To:	Commercial Real Estate Management, City of Toronto Metro Hall 2nd floor 55 John Street Toronto ON M5V 3C6	Addendum No:	05
		Project No:	21025 211018
Attention:	Bonita Lee	File No:	6-2-1
		Date:	November 28, 2024
		Pages (with cover):	22
Project:	Metro Hall Toronto Early Learning Child Care Centre	Delivery:	Electronic

1.1 Addendum No. 05

TORONTO
Metro Hall Fire Station &
Early Years Child Care Centre
Renovation

AV-101

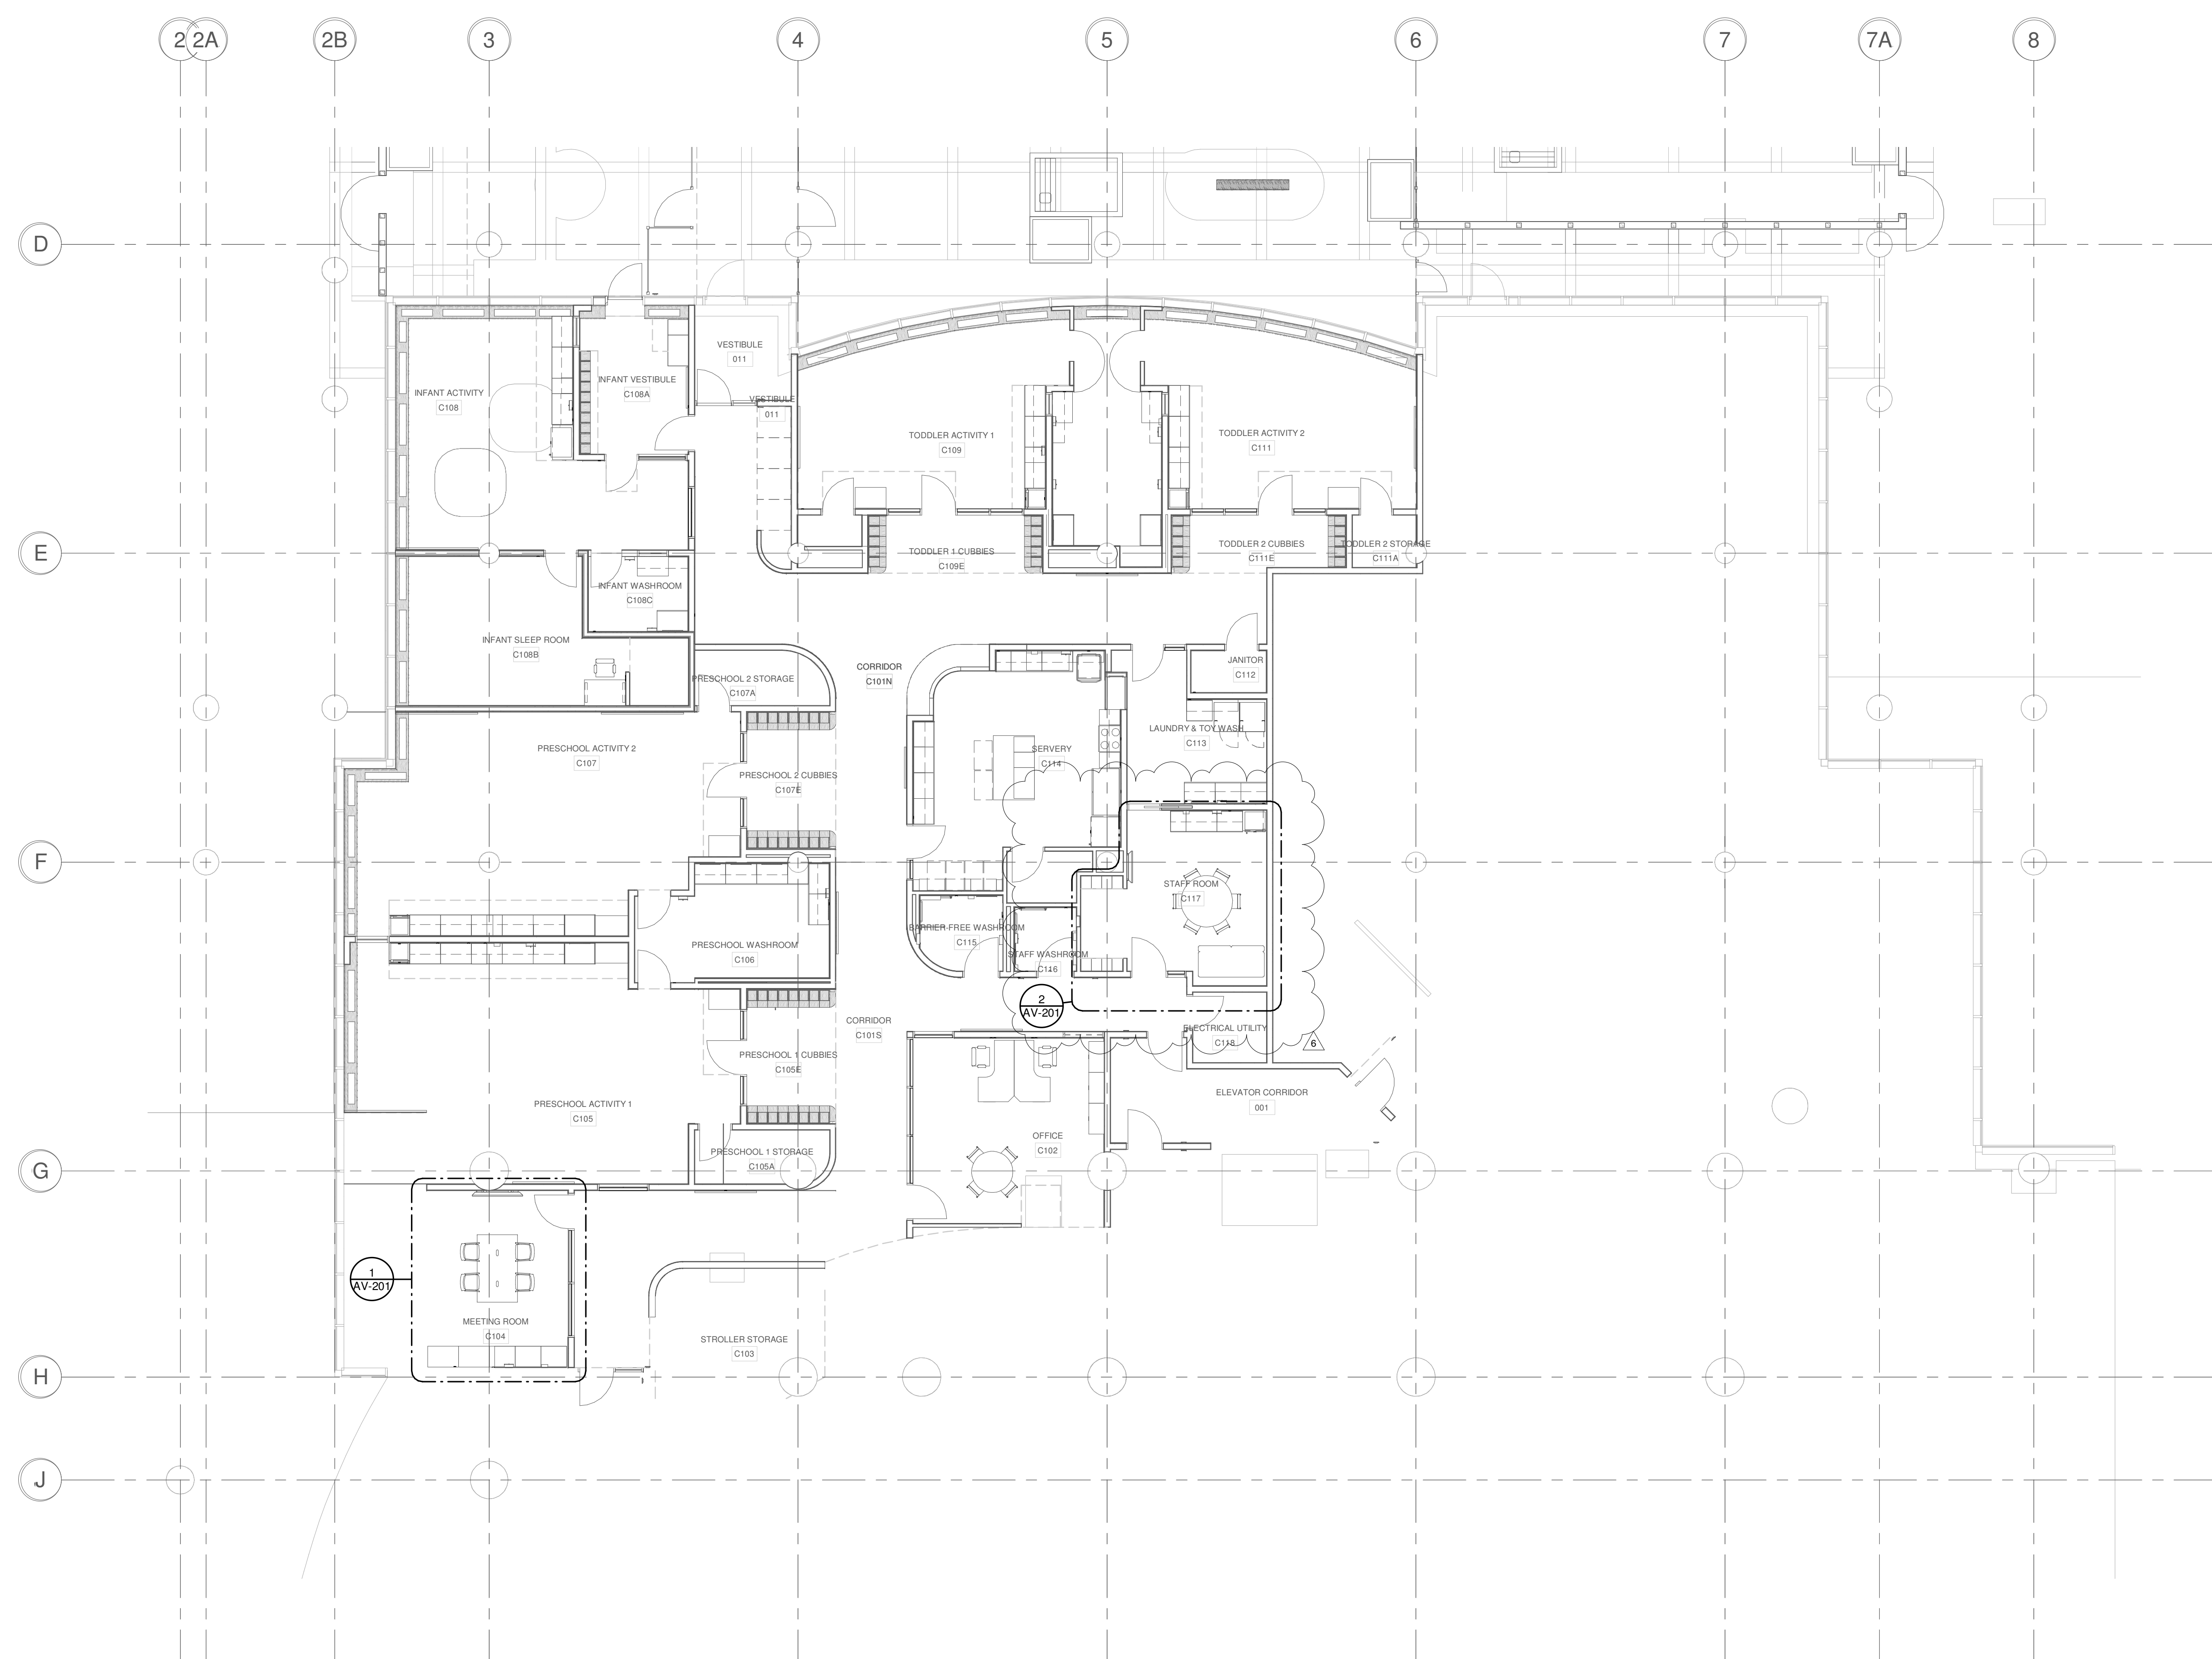
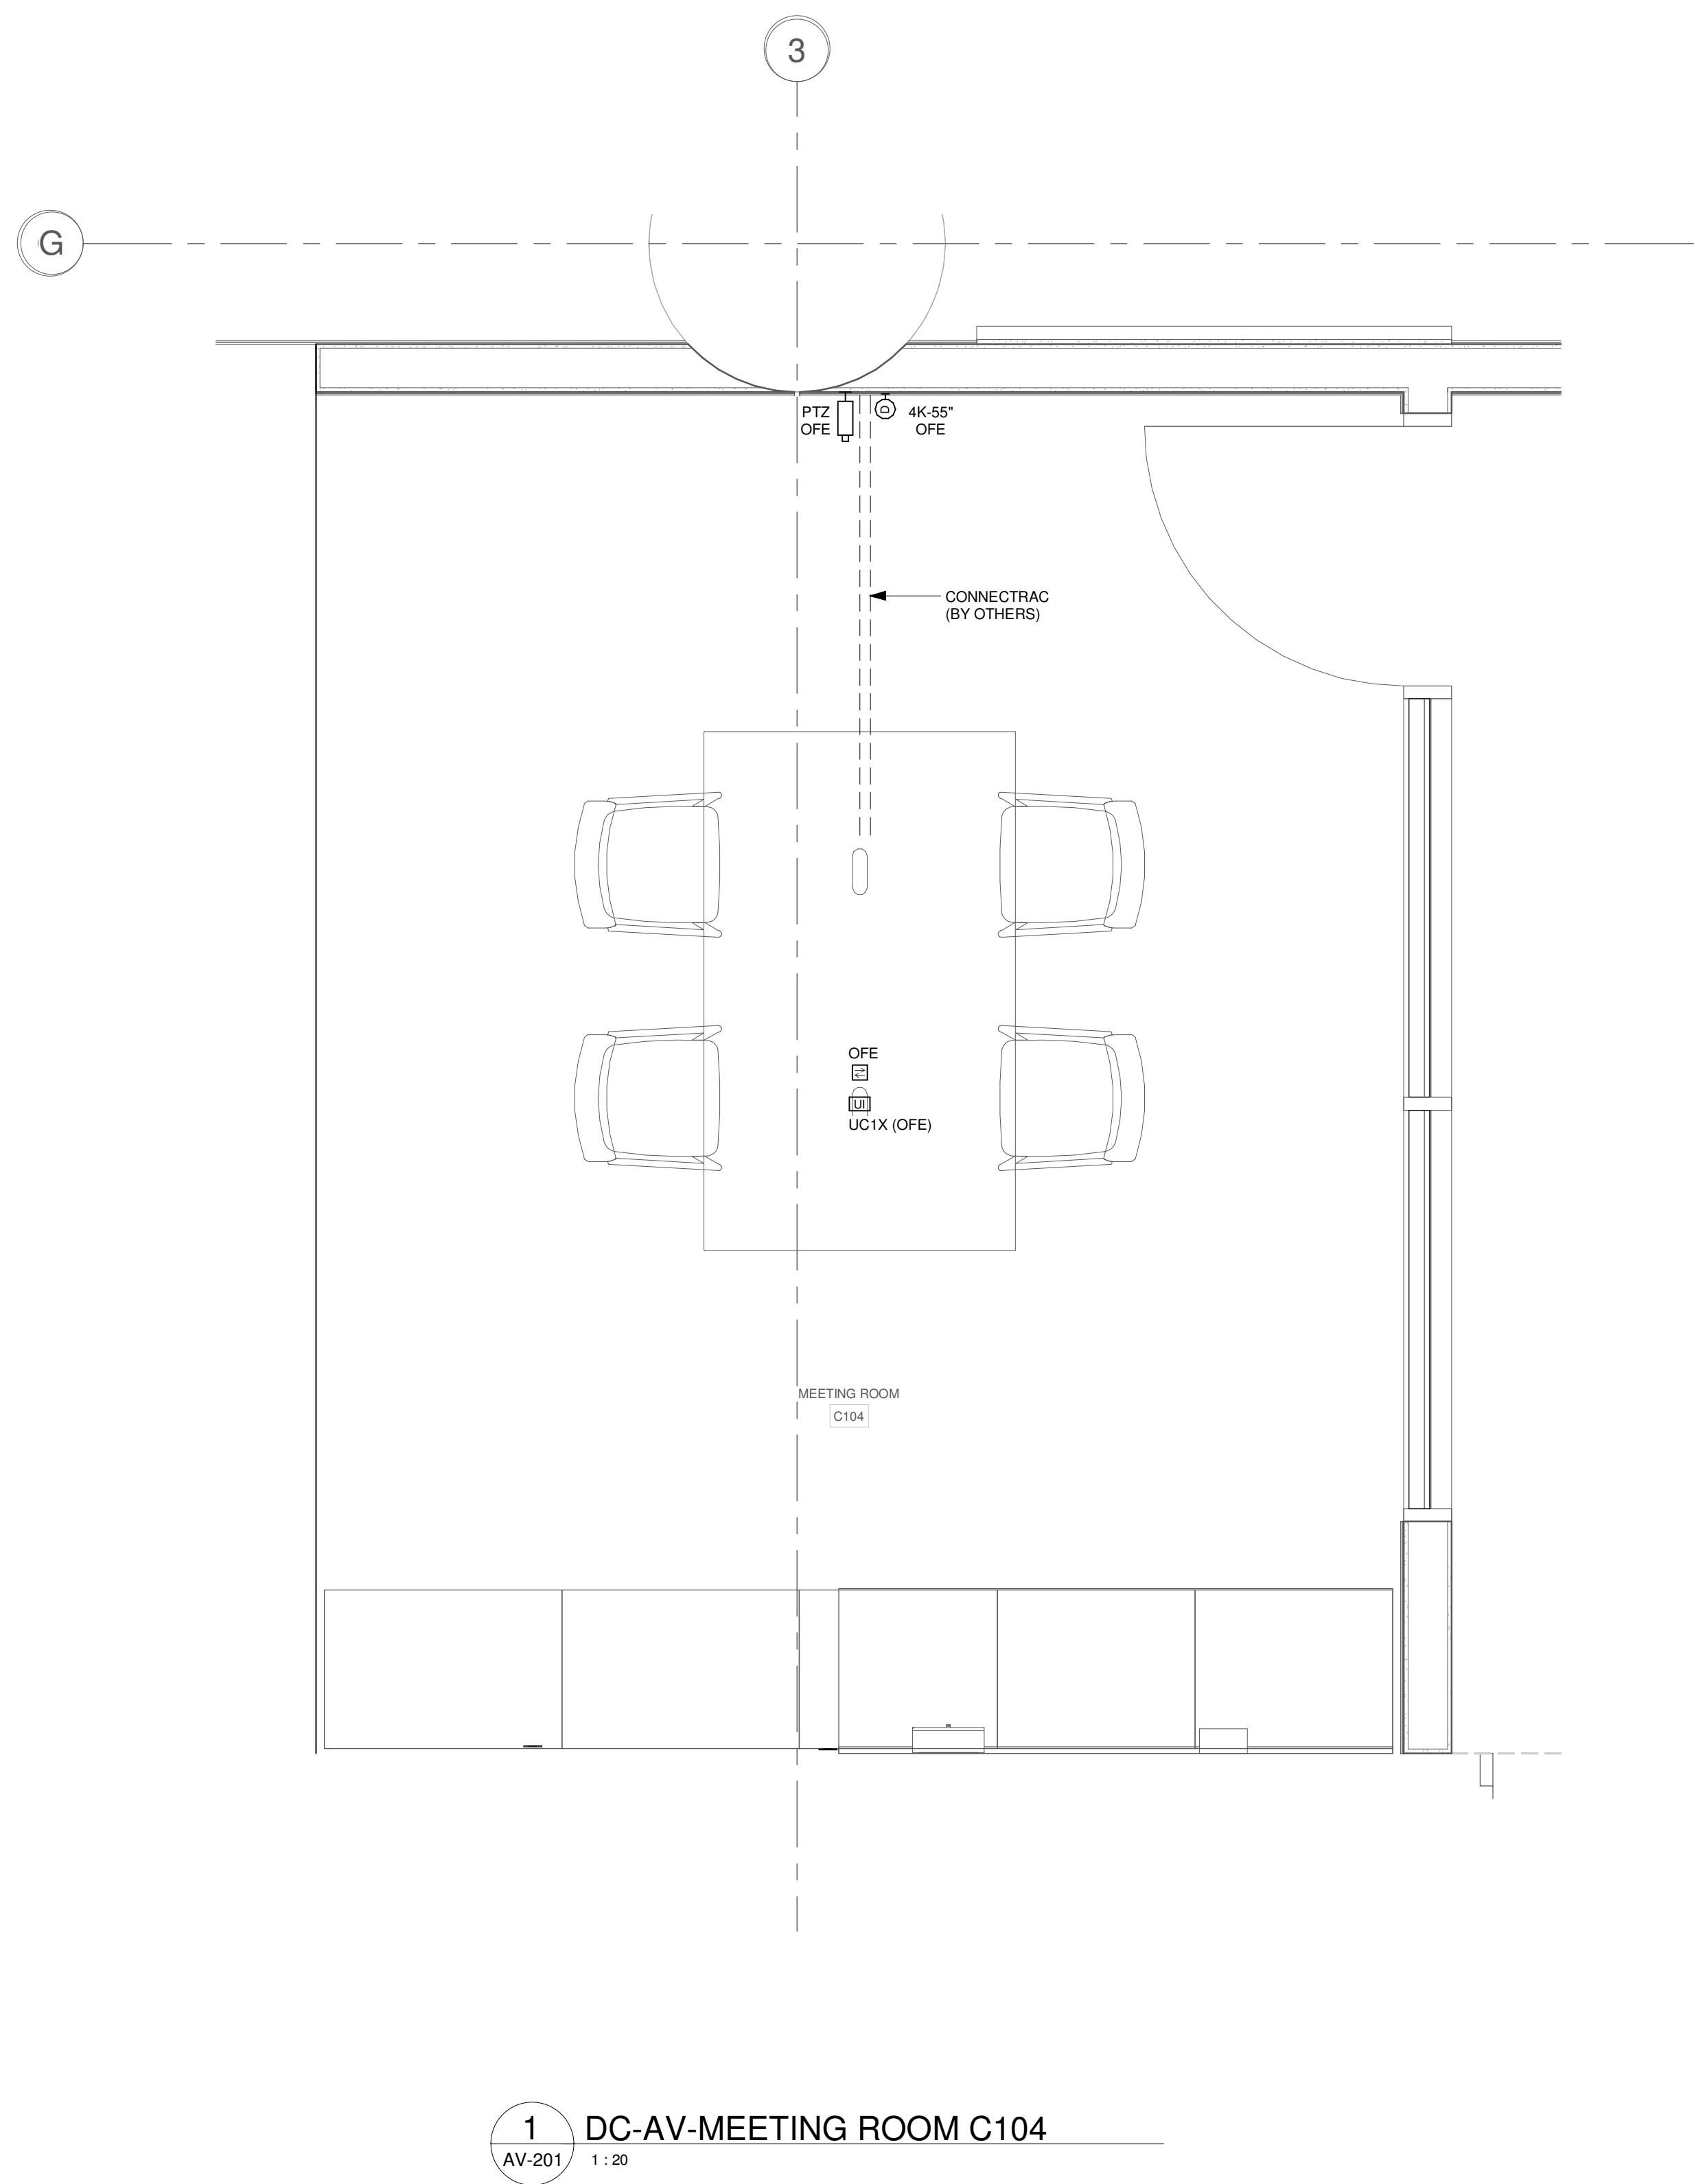
1. Reference: AV-101 – Daycare Audio Visual Layout (Drawing Re-Issued Herewith)

1.1. Add callout “2/AV201” at Staff [C117]
